**RE: Monarch-DENM Gravel Mine, File No. M-2022-009, 112c Permit Application,
Third General Adequacy Review and Geotechnical Review Response**

MONARCH-DENNM GRAVEL MINE
DRMS 112 PERMIT APPLICATION
WELD COUNTY, COLORADO

MINING PLAN
MAP

SHEET:
C-5

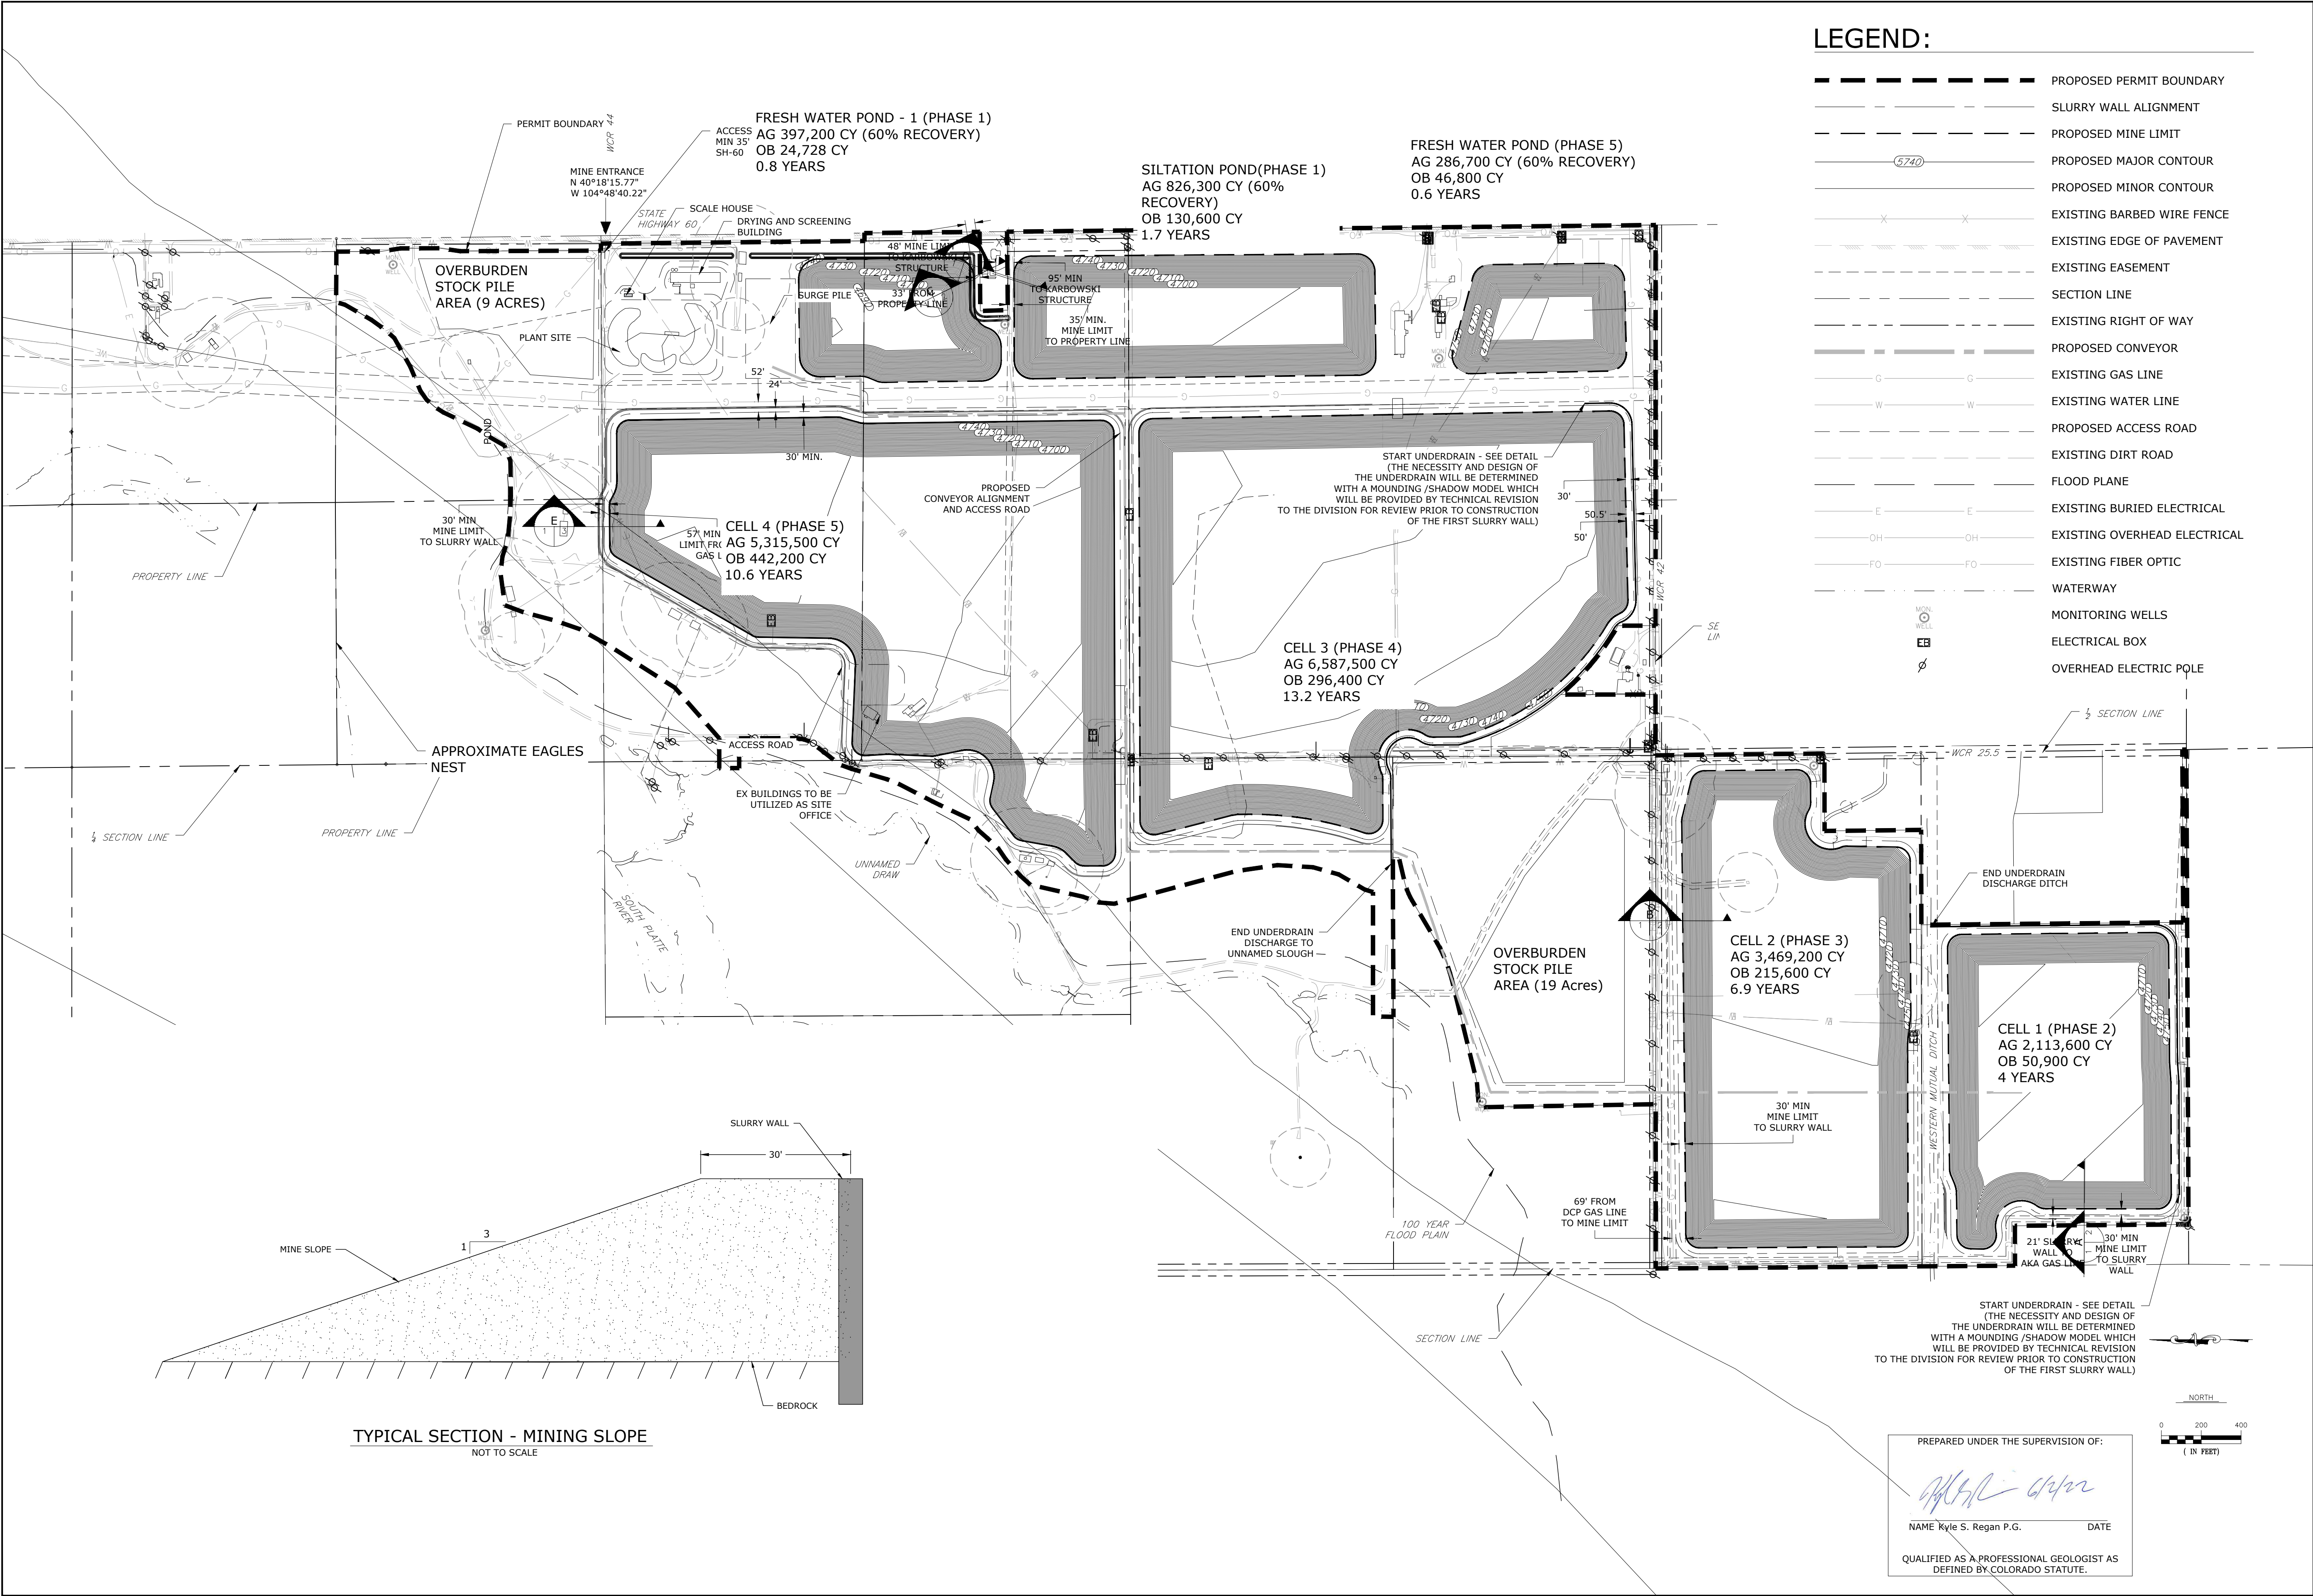
*Per our conversation on June 9, 2022, the Division requires that an underdrain be added to the Mining Plan and associated map (Exhibits C and D) with a commitment that this will be built prior to slurry wall construction. **Two underdrains have been added to the Mine Plan Map Exhibit C-5 south of Cell 1 and Cell 3, the upgradient side of the site. The following text has been added to the Mining Plan, Exhibit D:***

Explain the differences between Exhibit L and the Mining Plan Map, C-5. In particular, the volumes in Section B of the Reclamation Costs (reclamation of the Freshwater Pond and the Silt Pond) require explanation when compared to the volumes listed on C-5. For example, on the map the volumes for the Siltation Pond are 826,300 CY for AG and 130,600 CY for OB), and in the cost table the value is 655,000 CY (prior to multiplying by 50%).

There will be no mining below the groundwater table until the slurry wall is complete, tested and approved for each slurry wall lined cell. In order to mitigate mounding upgradient of the site two underdrains will be constructed prior to slurry wall construction on the southern end of Cell 1 and Cell 3. A mounding and shadow

groundwater model will be performed prior to construction to inform the design and necessity of the underdrains. The model will be provided to the Division when available. If the model demonstrates that excessive mounding is not anticipated at the site, MMMA may apply for a Technical Revision to remove either or both underdrains from the Mine Plan. Prior to starting construction of any slurry wall, the applicant shall apply for a Technical Revision with a slurry wall design and underdrain design report.

The Freshwater Pond is approximately 12 acres and will have 1' of topsoil placed in the pit which is already accounted for in line item B.4. The topsoil placed is approximately 20,000 cy. The total volume of material extracted from the pit is 422,000 cy minus 20,000 cy equals 402,000 cy.

I have changed the calculation for the siltation pond to the following reasoning. MMMA only needs 10 acres of siltation pond open at a time. The whole pond is approximately 25 acres. The total material removed is 956,900cy and topsoil added to the pit is approximately 41,000cy. The whole pit will require 915,900 cy of overburden to fill the whole 25 acre pit. $915,900 \text{ cy} / 25 \text{ acres} = 36,636 \text{ cy/acre}$. $36,636 \text{ cy/acre} \times 10 \text{ acres} \approx 366,000 \text{ cy of fill needed per 10 acres}$.
